## **Traffic Calming (Speed Humps) - Livingstone Avenue**

**Date:** September 6, 2024

**From:** Director, Traffic Management, Transportation Services

**RE: Livingstone Avenue, between Jimmy Wisdom Way and Times Road Speed Hump Investigative Summary**

Attachment 2: Speed Hump Locations Plan - Livingstone Avenue

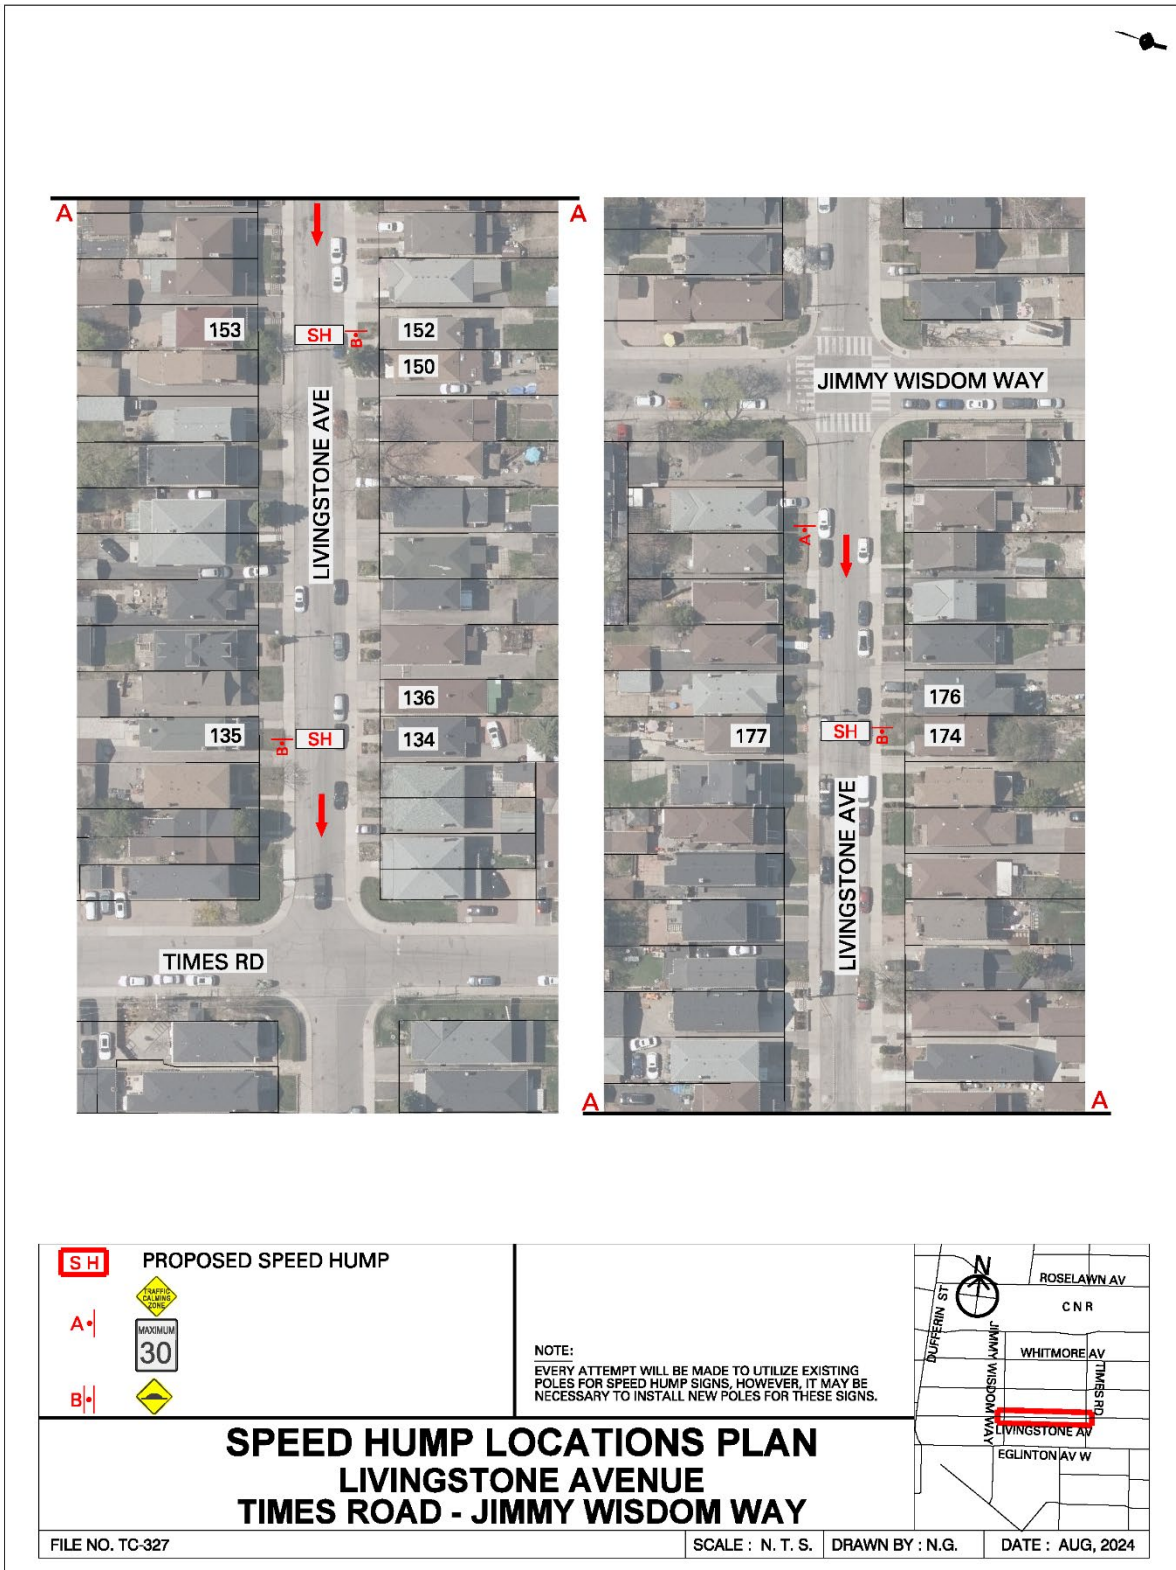
Toronto Fire Services does not support this proposed speed hump installation as it may negatively impact service delivery. The physical restrictions imposed by speed humps have a greater impact on fire vehicles. Response time increases with every obstacle encountered responding to any emergency incident and the cumulative impact of several speed humps can increase responses times.

Toronto Fire Services is supportive of initiatives that improve safety for all citizens of and visitors to the City of Toronto. However, careful consideration must be given to accepting a delay to emergency response vehicles as a compromise to combat the risks presented by all vehicular traffic. Our recommendation is that non-physical measures be considered and evaluated to determine if desired results can be obtained without imposing a physical obstacle to emergency vehicles.
